FIRE STATION BATHROOM REMODEL

ADDENDUM NO. 2

Issued: June 8, 2023

FINISH MATERIALS:

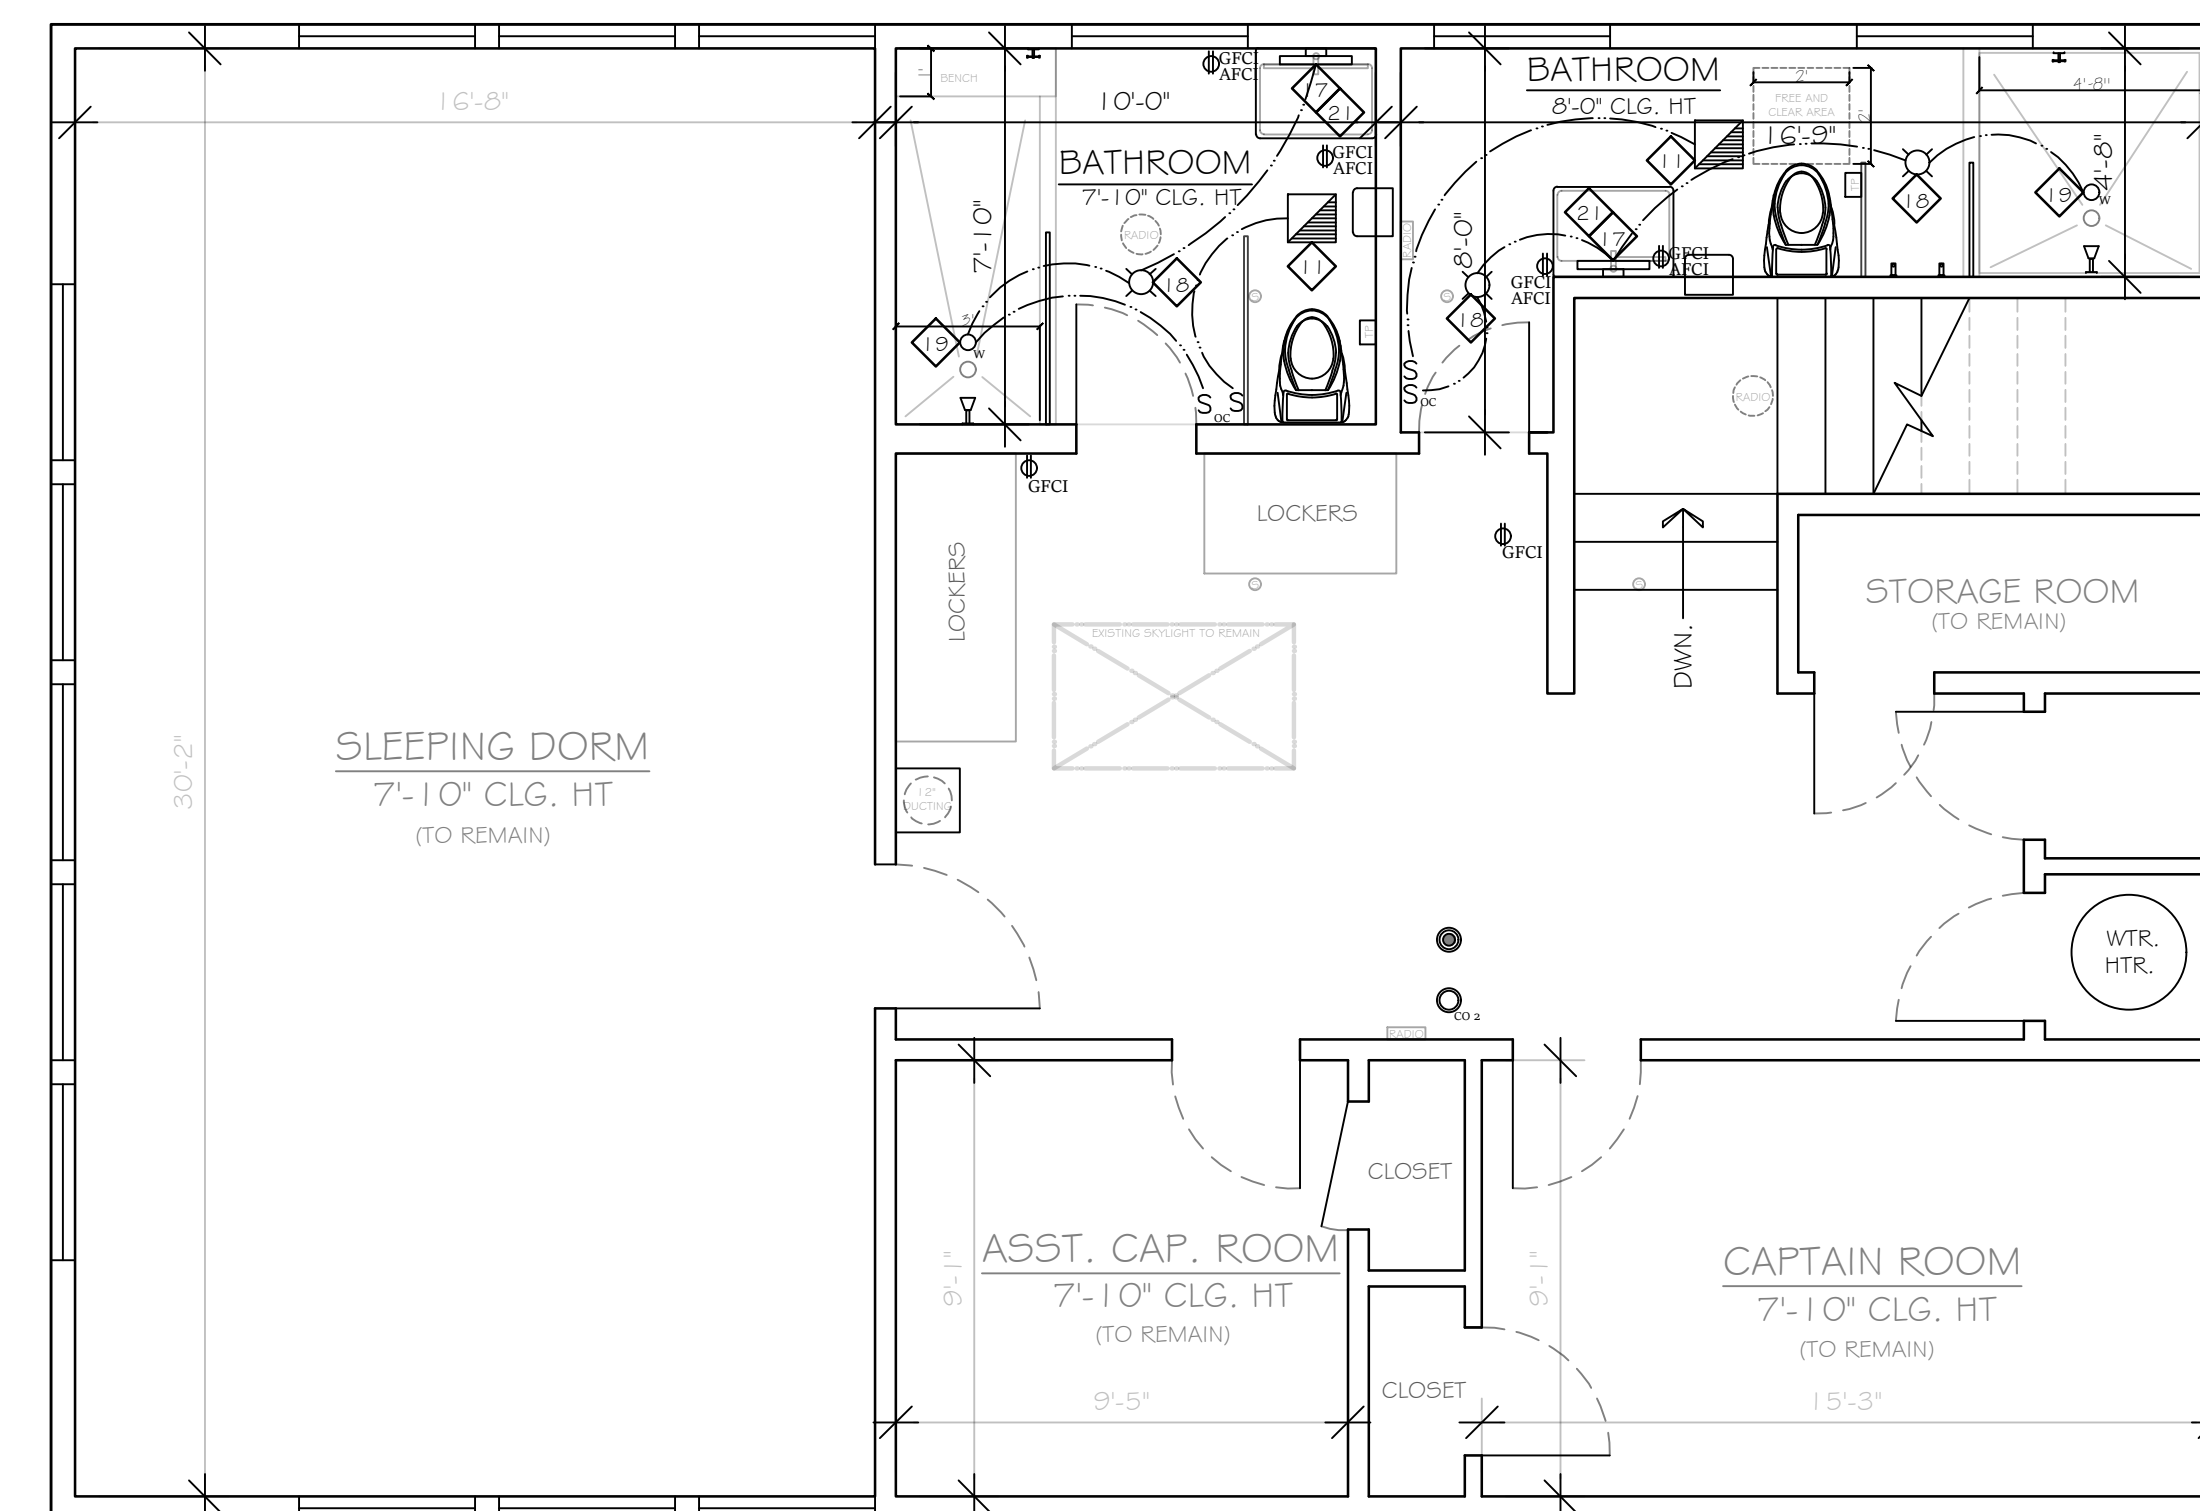
1. **Question:** The plans are vague. It's hard to tell if the tile goes just in the showers or is it a wainscot all the way around the bathrooms. Plans call for minimum 6 ft, but don't say where exactly. Please advise.

- Please see revised plan set and details attached (Attachment 1).
2. **Question:** When can we go look at the space if able?
 - You can call 831-648-5722 x4201 to set up a time to view the space.

FM-1 NONABSORBENT SURFACE IN SHOWER & TUB COMPARTMENTS ON WALL SURFACES SHALL EXTEND TO A HEIGHT OF NOT LESS THAN 6'-0" A.F.F. (OWNER SUPPLIED)
